MAJOR PROJECT ASSESSMENT: Hoxton Park Warehouse Project

Director-General's
Environmental Assessment Report
Section 75I of the
Environmental Planning and Assessment Act 1979

May 2010

Figure 5: Landscaping Plan

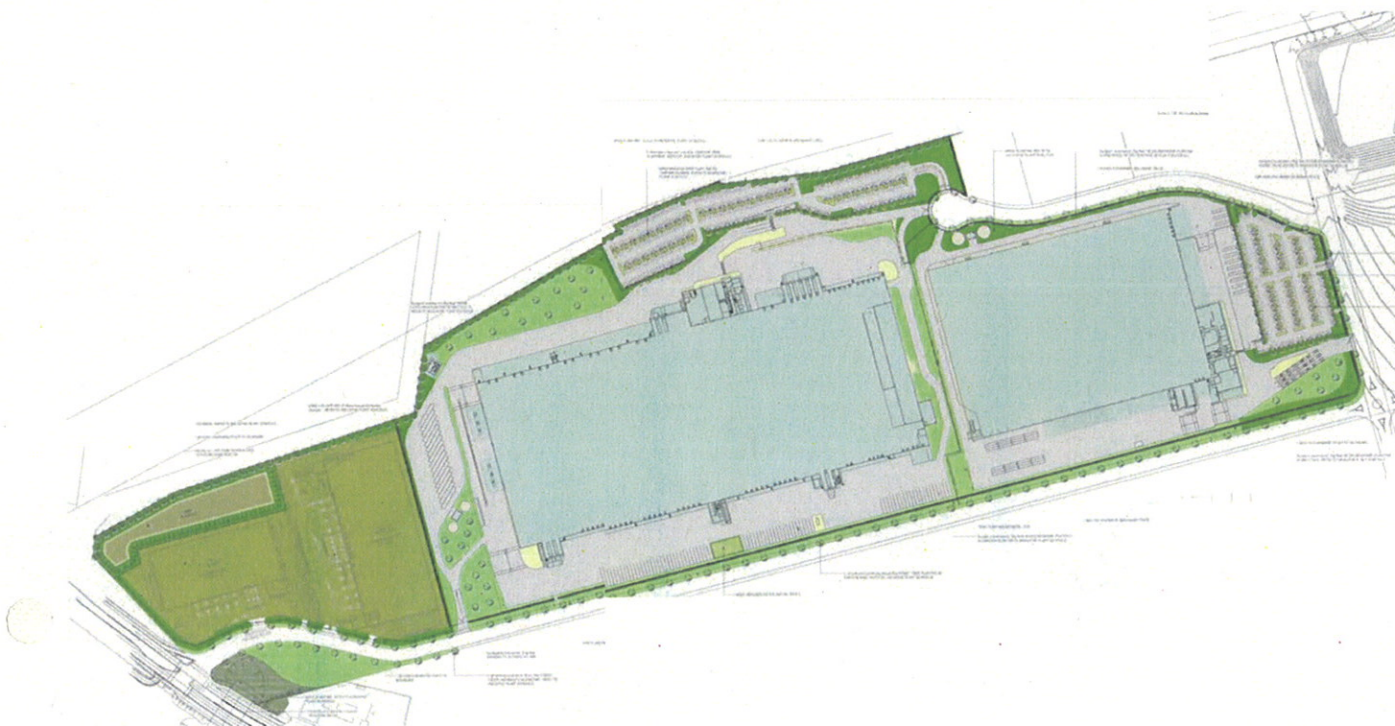
The site would be accessed via Cowpasture Road and the Department considers that the presentation of the access should be of a high standard. The proposed landscaping for the site entrance is depicted in Figure 15. While the landscaping for the site and site entrance is generally adequate, the Department considers that the landscaping for the site could be improved. In particular, the Department considers that the landscape plan should be revised to include:

- a design for the site entrance which includes visual screening in the form of both built elements and landscaping that identifies the former heritage values and historical uses of the site;
- the incorporation of the recommendations of the *Former Hoxton Park Airport Interpretation Plan and Implementation Strategy*, submitted with the EA, in the design of the site entrance and landscaping for the site; and
- landscaping for the remainder of the site.

It is noted that the area set aside for landscaping may also need to be modified to accommodate the additional area required for the widening of the road reserve for the access road (as discussed in Section 5.2). Mirvac should therefore take this requirement into consideration when revising the landscape plan. These requirements have been incorporated into the conditions of approval.

Figure 10: Conceptual Stormwater Management Strategy

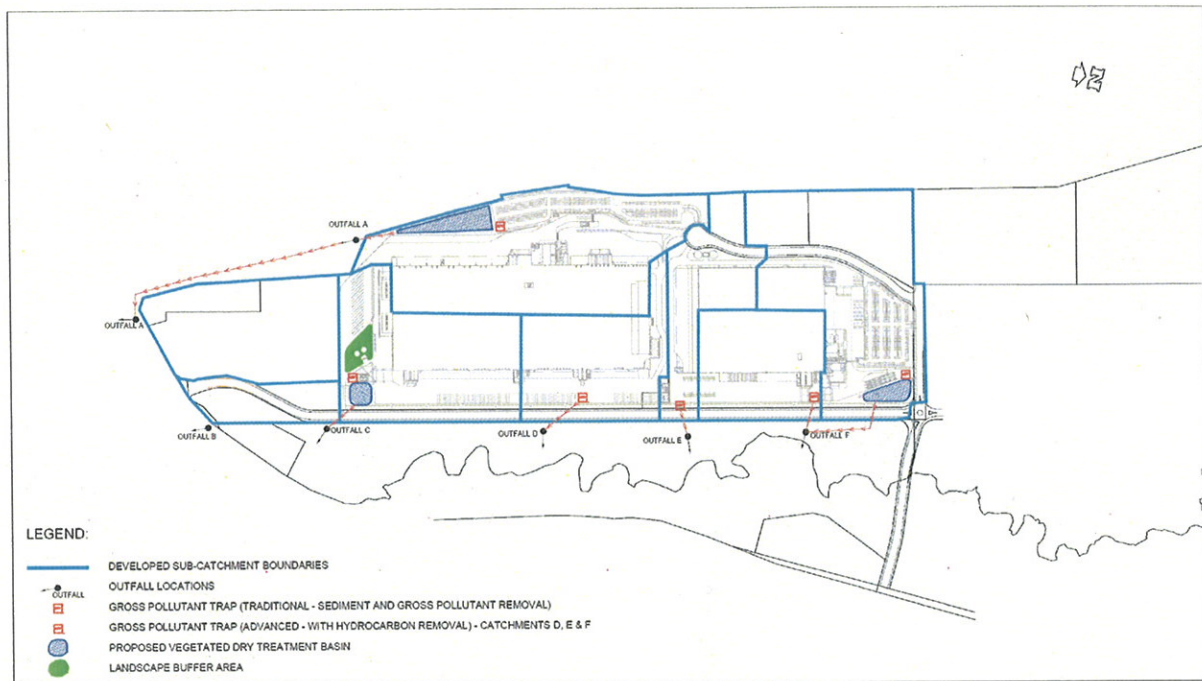
Council and the Department are satisfied that adequate drainage has been provided to drain the development and that the drainage design is appropriate. In addition, the Department considers that the level of stormwater treatment that would be undertaken prior to discharge would be effective.

Nonetheless, the Department has recommended a condition of approval requiring the conceptual design of the stormwater management system to be finalised in a stormwater management plan that includes measures to manage, treat and dispose of stormwater and contingency measures should exceedences be detected. In addition, the Department considers that Mirvac should be required to submit details of stormwater management measures with any project/development application for the

Figure 11: Surrounding Road Network and Cowpasture Road Upgrades

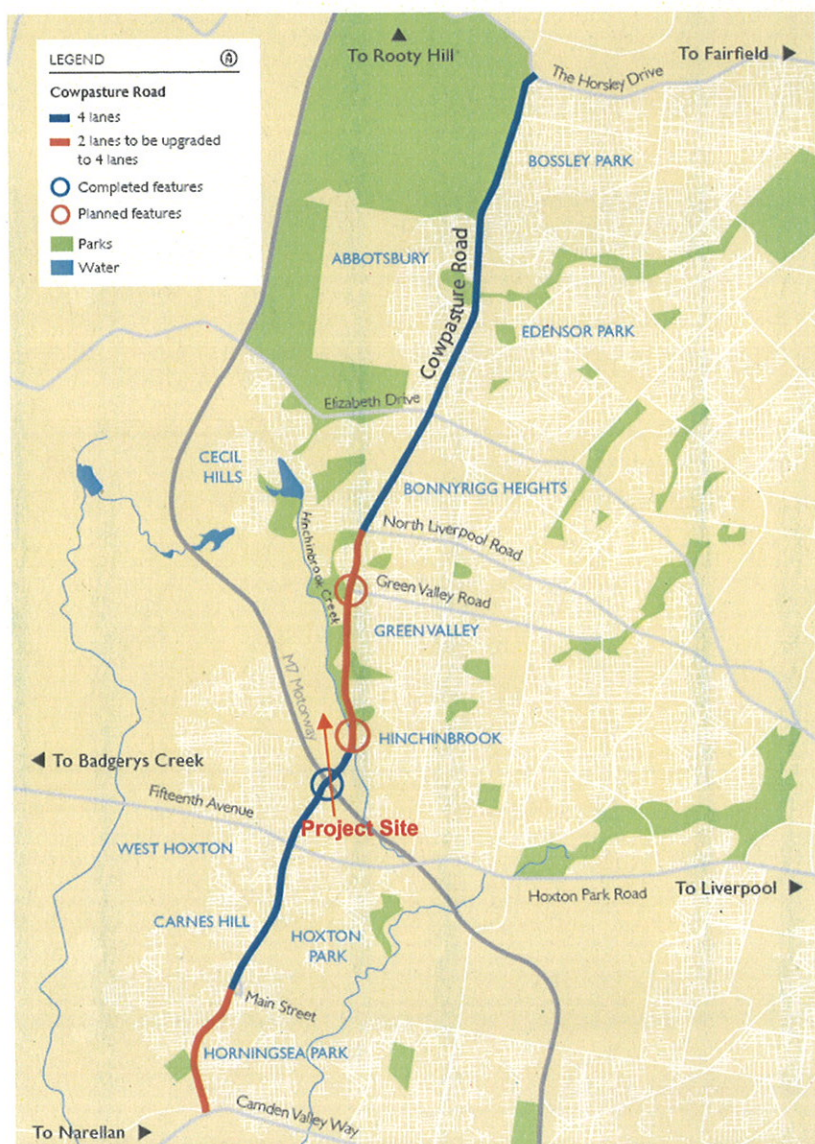
The RTA has raised a number of concerns relating to the access, including:

- questioning the assumptions made by Mirvac in relation to the traffic split. The RTA consider that 70% of traffic would travel to and from the south, with the remaining 30% travelling to/from the north;
- that the new access does not cater for the swept path for B-double movements and vehicles exiting south are likely to experience delays due to only two exit lanes being provided; and
- questioning the assumptions made by Mirvac in relation to the phasing of traffic lights. RTA has raised concerns about the longer “green time” (i.e., length of time traffic signals remain green) that Mirvac has allocated to vehicles exiting the site in its modelling and indicated that this “green time” would create unacceptable queues on Cowpasture Road.

The RTA considers that the efficiency of the Cowpasture Road and the M7 should not be compromised by the project, and that the “green time” allocated to vehicles exiting the site should be reduced. However, this is likely to increase the queues on the access road. The RTA considers that there are a number of options to address these issues including augmenting the access to include an additional left turn slip lane, or construct a second access to the site.

The RTA has agreed that augmentation of the intersection is not required provided that:

- the access road reserve is widened by an additional 3.5m to allow an additional turning lane to be constructed if it is required in the future;
- traffic management plans are implemented for the Big W and Dick Smith warehouses to minimise vehicle movements in the peak period; and
- consideration is given to the second access being built sooner to reduce potential queues for vehicles exiting the site during peak periods.

- Mirvac to widen the access road reserve by 3.5m for approximately 50m to accommodate any future upgrade to the access road as required;
- Mirvac to modify the concept plan to include provisions for a second access. The modification must be submitted within 4 months of the concept plan being approved and the Department has outlined a number of matters that would need to be addressed as part of the modification to minimise and manage any potential environmental impacts associated with the second access; and
- Traffic management plans to be prepared and implemented prior to the operation of the Big W and Dick Smith Warehouses detailing measures to minimise vehicle movements in peak periods, and in particular, the peak afternoon period.

Figure 12: Site Access and Traffic Management During Construction

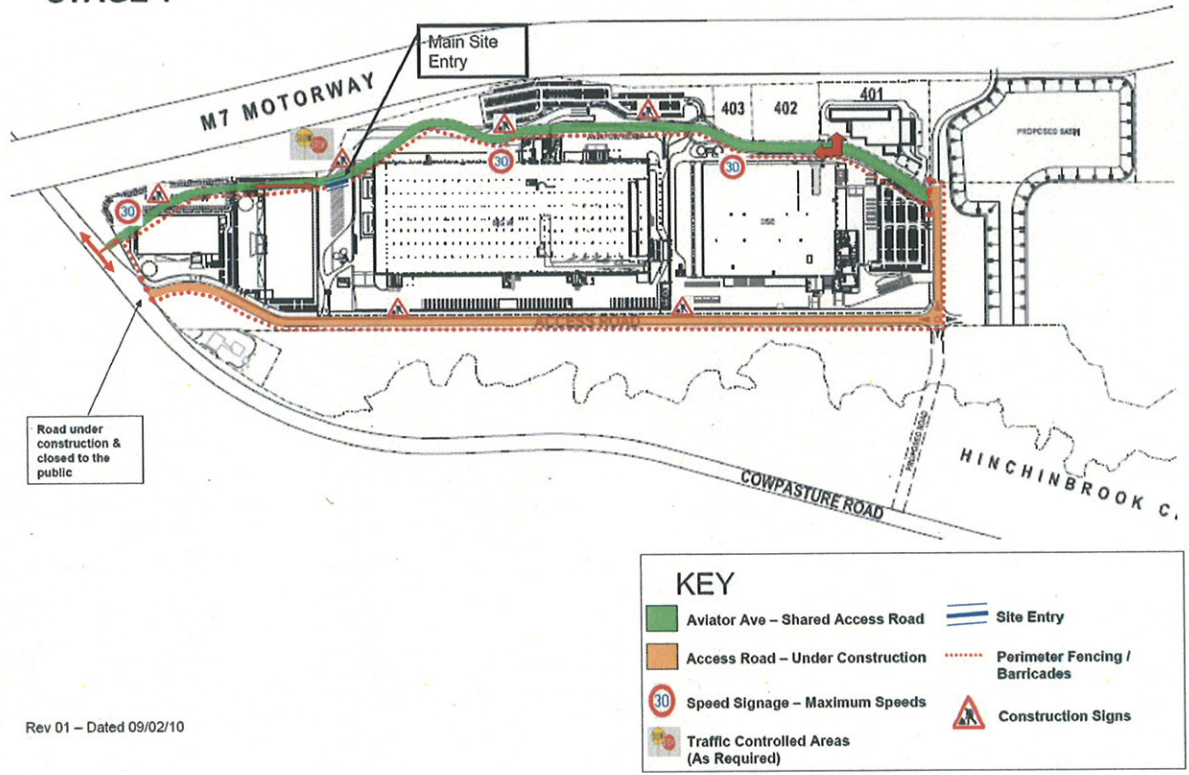
During the initial stages of construction (bulk earthworks and road construction), traffic would access the site via the existing entrance that serviced the aerodrome, which is signalled (see Figure 12). It is considered that the existing access has sufficient capacity to accommodate construction traffic. However, Mirvac has prepared a construction and environmental management plan (CEMP) which details a number of controls to manage construction traffic including the installation of signage and the implementation of maximum speeds limits for construction traffic (see Figure 12). The Department is satisfied that the measures proposed by Mirvac to manage construction traffic are appropriate and has

recommended conditions of approval requiring Mirvac to implement the measures outlined in the CEMP during construction.
